**Re: Sarjeant Waverly Pit No.2
OWRA S53 Environmental Compliance Application
Township of Tiny, County of Simcoe, Ontario
Project No.: MCG102990 2021**

R.J. Burnside & Associates Limited (Burnside) was retained by the Township of Tiny (Township) to complete a peer review of the documentation prepared in support of a Ministry of Environment Conservation and Parks (MECP) Environmental Compliance Approval (ECA) application. The application is for the wash water facility at the Waverly pit No. 2, which is owned by The Sarjeant Company Ltd (Sarjeant). The documents reviewed included:

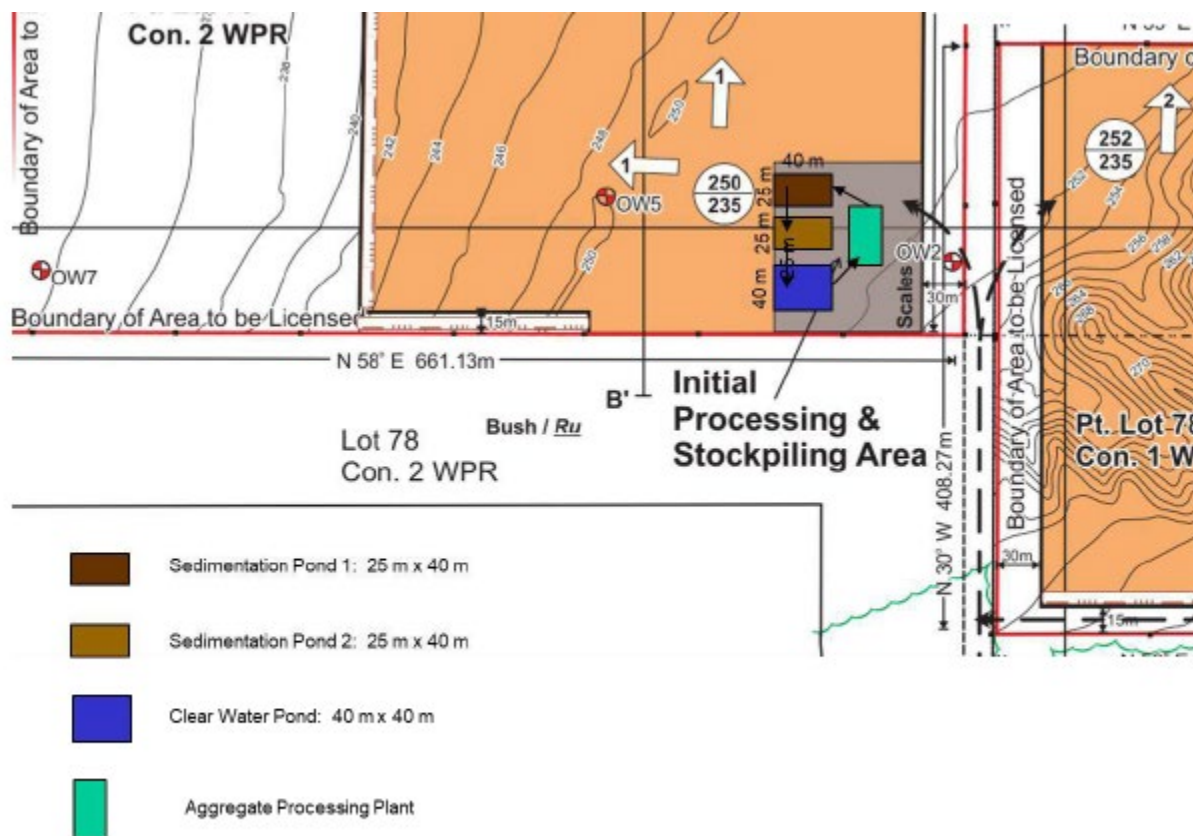
Source Pond A is outside of the licensed area so it is not clear how it will be regulated as there does not appear to be any information on the site plans on the long-term use of the pond once the Pit is no longer in use. Pond A is fairly large, and a significant amount of material will be removed during its construction. The proponent should indicate what this material will be used for since it is outside the licensed area.

The Operational Plan (Page 2 of 3) of the site plans submitted to the Ministry of Natural Resources and Forestry (MNR) indicates that the washing operation will be located within the processing area. Since the only use for Pond A is a source of wash water used as part of the site operations, it is not clear why the pond is located outside of the licensed area. The proponent should confirm with the MNR that the location of the pond has been approved. The pond is much smaller than Source B, however there is no rationale given for the size of the ponds. Similarly, there is no data to support the need for two ponds. As can be seen on Figure 10 below, most of Pond B is above the water table so it is not clear how the pond will support the proposed water taking.

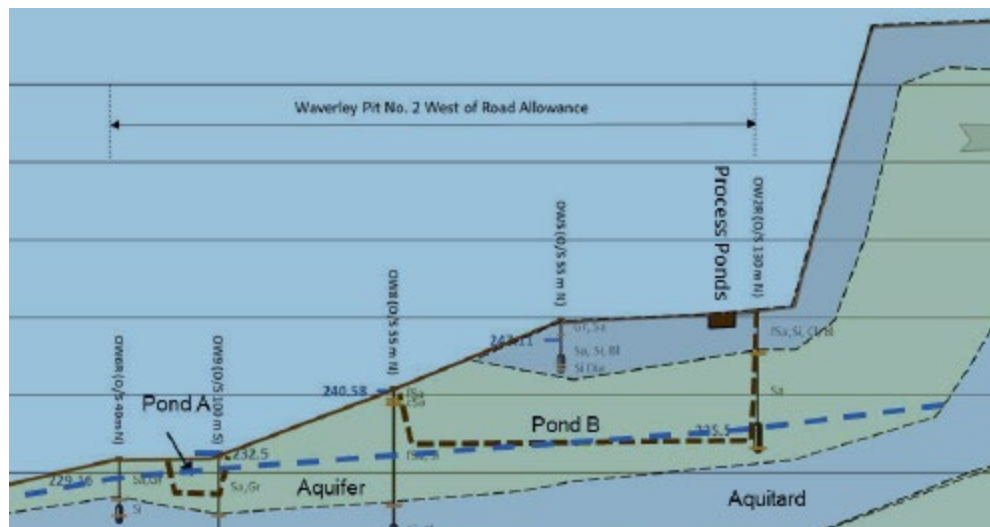
Burnside supports the lining of the sedimentation and clean water ponds. However, since the ponds are lined, the statement “Some water leakage from the sedimentation ponds can be expected to occur initially, and then decrease as a layer of fine-grained sediment covers the pond bottom” should be clarified. The Harden report provides a detailed rationale explaining why off-site movement of fine-grained particles will not occur and indicates “Limited operational flexibility is requested for the wash plant and sedimentation pond locations. Due to the nature of the aggregate mining process, phases of extraction occur in different areas of the site and as such the wash plant and sedimentation ponds must be moved as the mining progresses.” The proponent should provide more detail on how often and where the ponds / wash plant will be moved. They should also confirm that there will be sufficient silt / clay on site to line the ponds (particularly if the location is to be moved several times) to the specifications indicated in the July report.

The proponent should retain a geotechnical engineer to document the construction of the ponds (at both the original and any subsequent locations). A letter confirming that the thickness and hydraulic conductivity of the liner conforms with the design specifications should be provided. The use of a geosynthetic liner is encouraged to reduce the potential for leaks. The proposed liner will be constructed from on-site silt and clay, and it is anticipated that the material that settles out in the wash ponds will be comprised of similar material. As a result, the use of a geosynthetic liner will make it easier to differentiate the material to be removed during pond maintenance.
